TITLE : AIR CONDITIONING - PRESSURE CONTROL AND MONITORING - REPLACE THE  
SUPPORT BRACKETS FOR THE OUTFLOW VALVE 10HL

MODIFICATION No. : 30421K6790

This page transmits Revision No. 01 of Service Bulletin No. A320-21-1125.

NB6 21 1125 AAMA-A

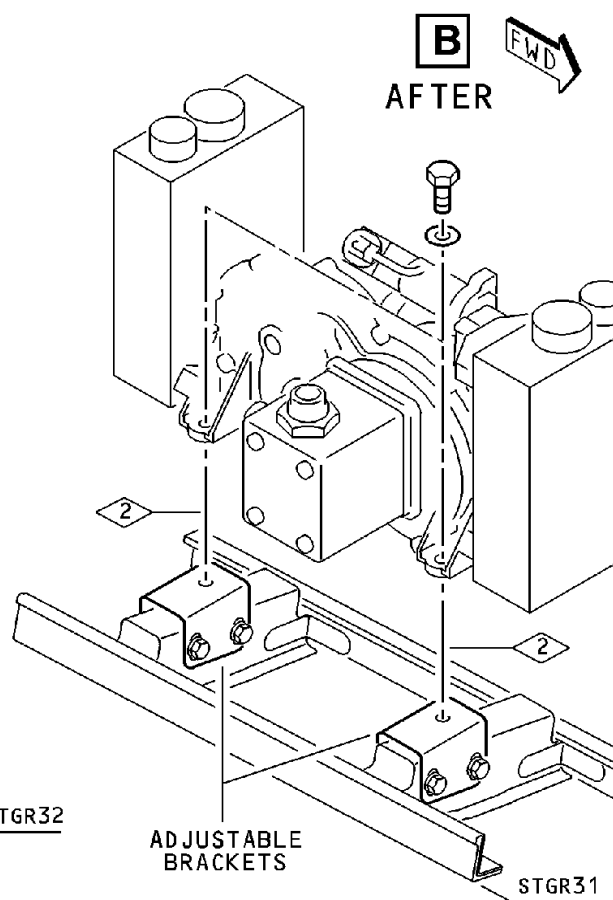
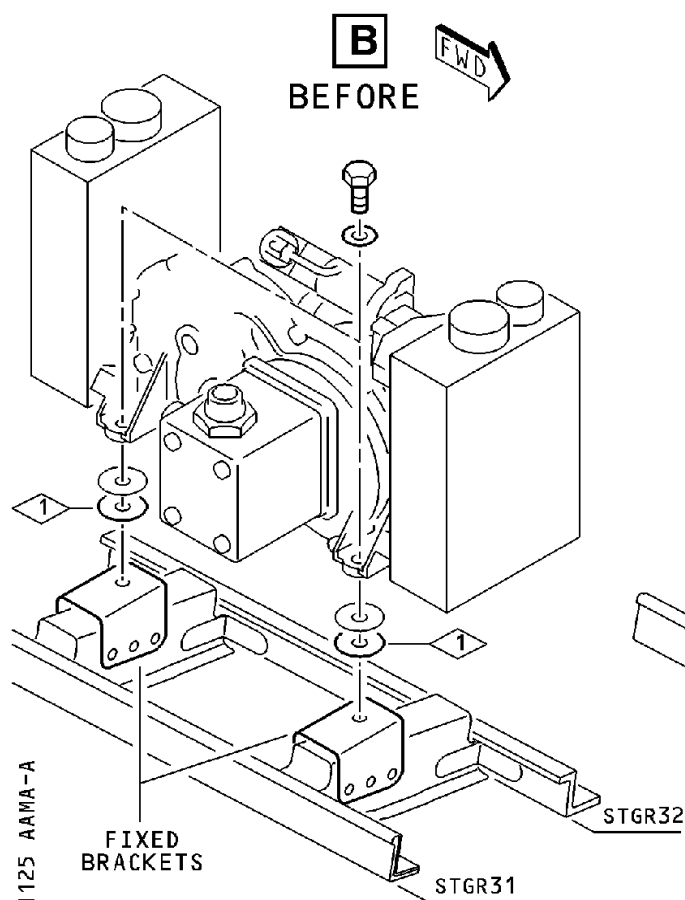
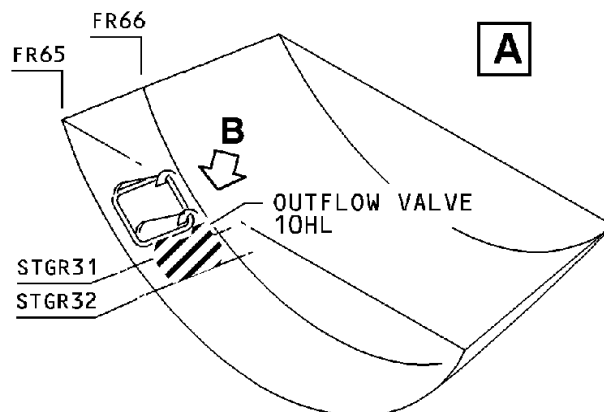
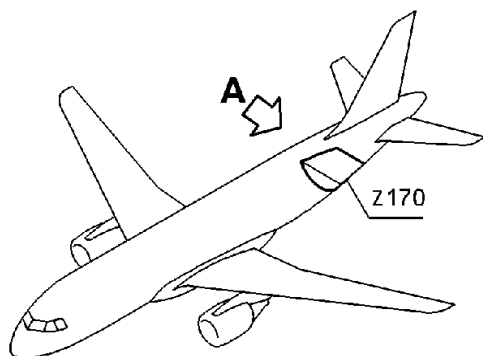
- 1 A GAP IS POSSIBLE BETWEEN THE SUPPORT BRACKETS AND THE OUTFLOW VALVE 10HL. ANY GAP HAS BEEN BALANCED BY WASHERS BEFORE DELIVERY OF THE AIRCRAFT.
- 2 NO GAP IS POSSIBLE AFTER THE INSTALLATION OF ADJUSTABLE BRACKETS.

Figure 1 Sheet 1  
Replacement of Support Brackets

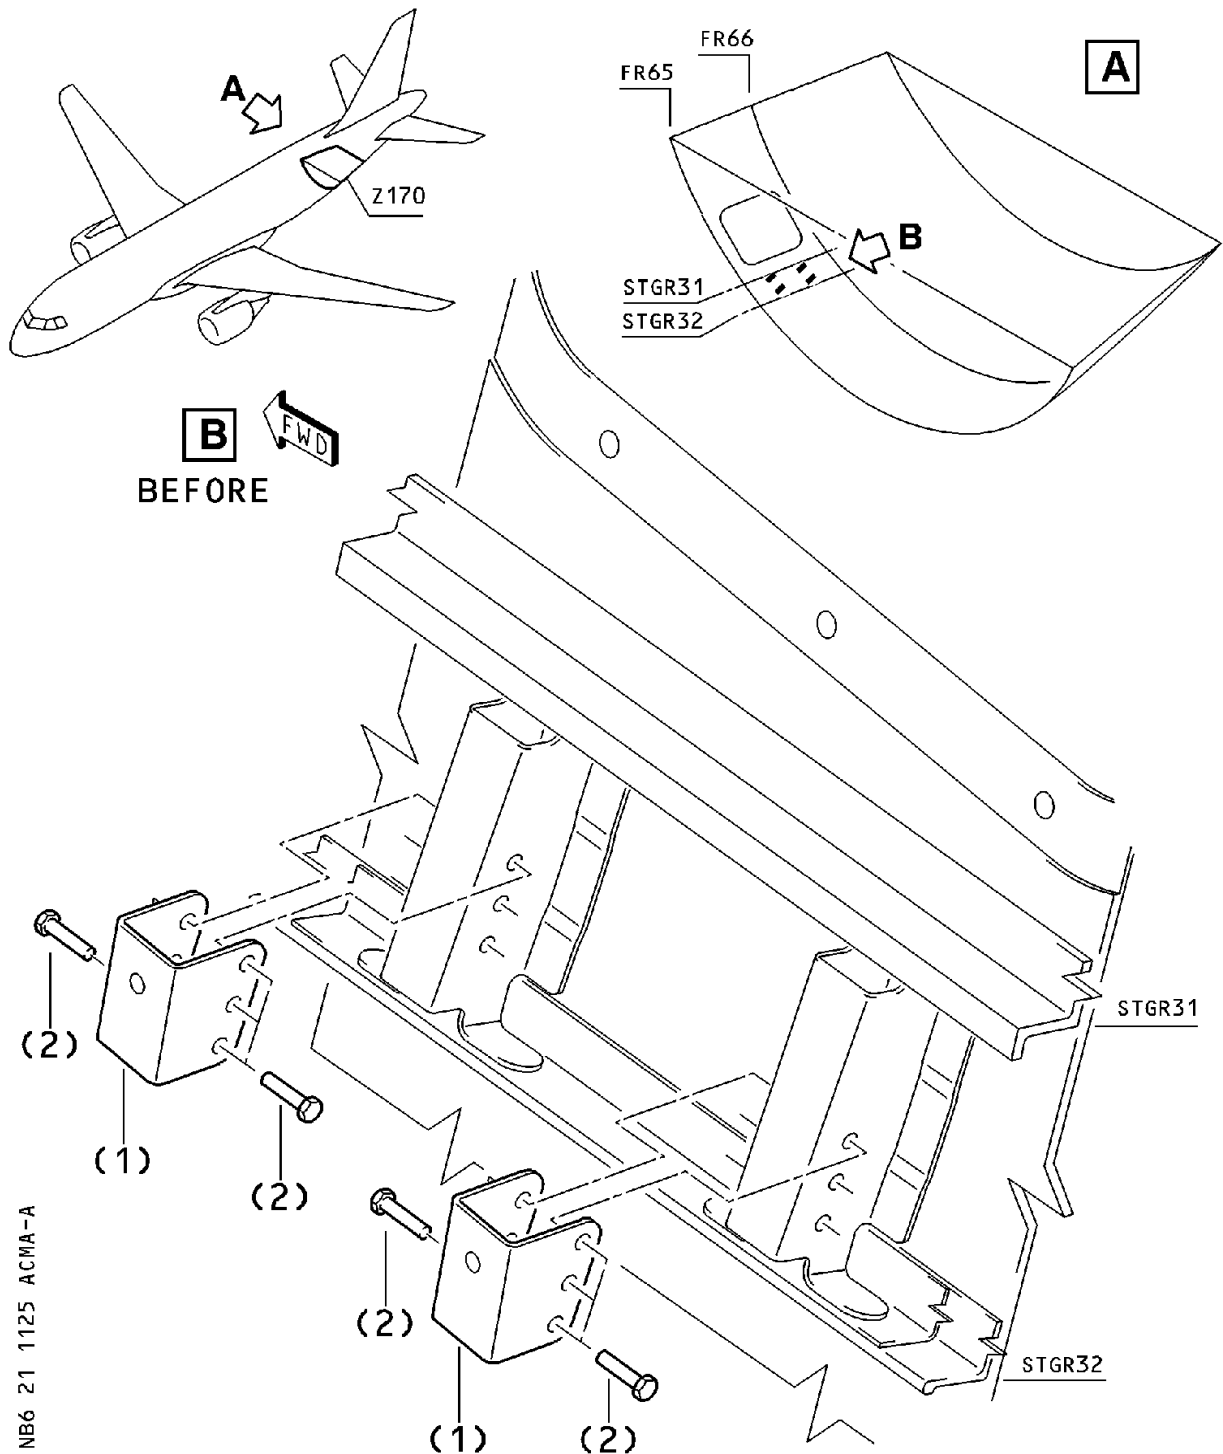
- (a) Do a modification to the support brackets at the outflow valve 10HL.
  - 1 Remove the outflow valve 10HL between FR65 and FR66, refer to AMM 21-31-51 Page block 401.
  - 2 From the support brackets between STGR 31 and STGR 32, RH, remove the bolts, refer to SRM 51-42-11 .  
Refer to Figure 1 , Sheet 1 , Detail A and B  
Remove :

- 3 Remove the brackets.  
Refer to Figure 1 , Sheet 1 , Detail A and B  
Remove :

Figure 1 Sheet 2  
Replacement of Support Brackets

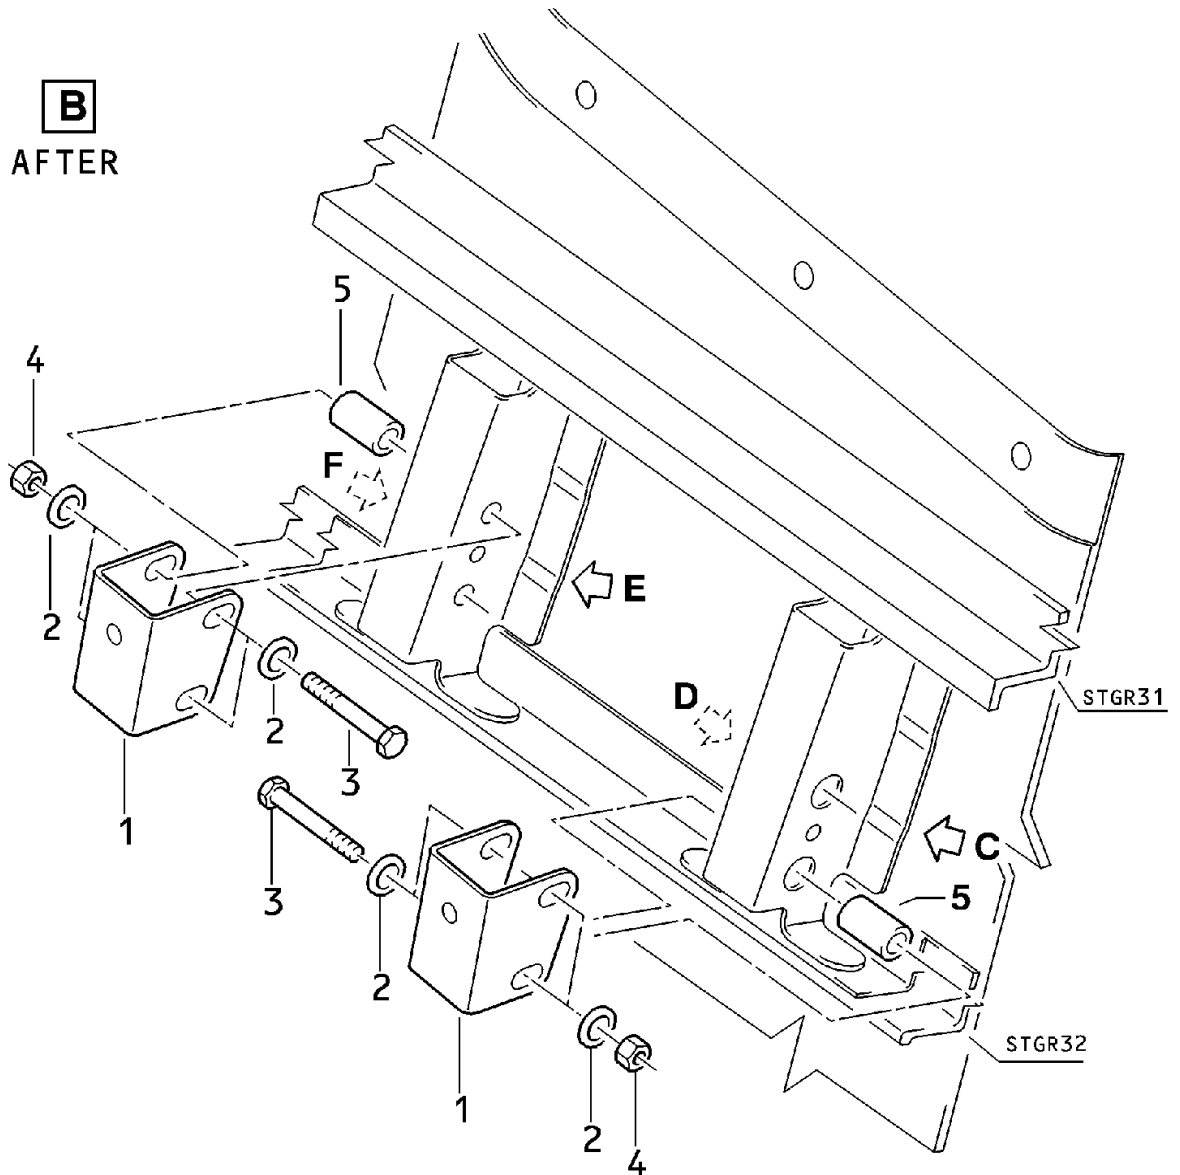
- 7 Install the sleeves to the structure.  
Refer to Figure 1 , Sheet 2

- 8 Install the adjustable brackets.

Figure 1 Sheet 3  
Replacement of Support Brackets

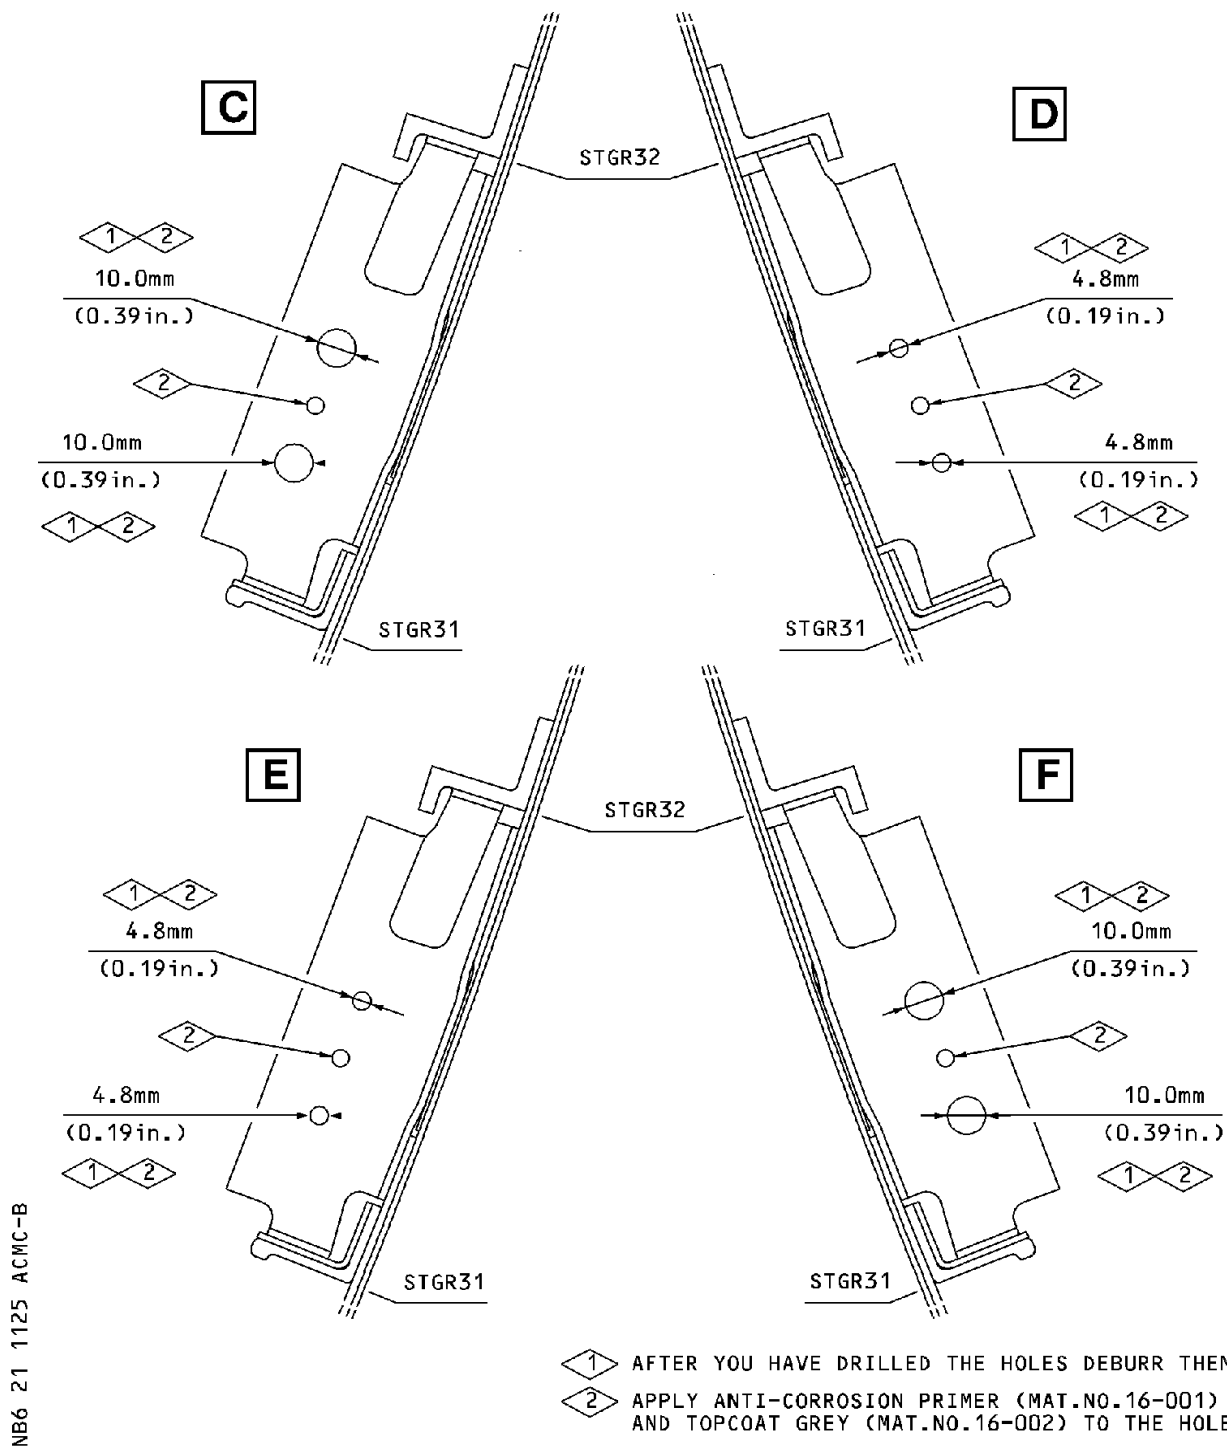
This Revision has been issued to correct the details showing the hole diameters at Figure 1, Sheet 3.

- Illustration, Figure 1, Sheet 3, hole diameters revised.

(0.19in.) dia. and deburr them as shown in Figure 1 ,  
Sheet 2 and Sheet 3 , Detail D and E.

- 5 Between STGR 31 and STGR 32, RH, drill the holes 10,0 mm  
(0.39 in.) dia. and deburr them as shown in Figure 1 ,  
Sheet 2 and Sheet 3 , Detail C and F.
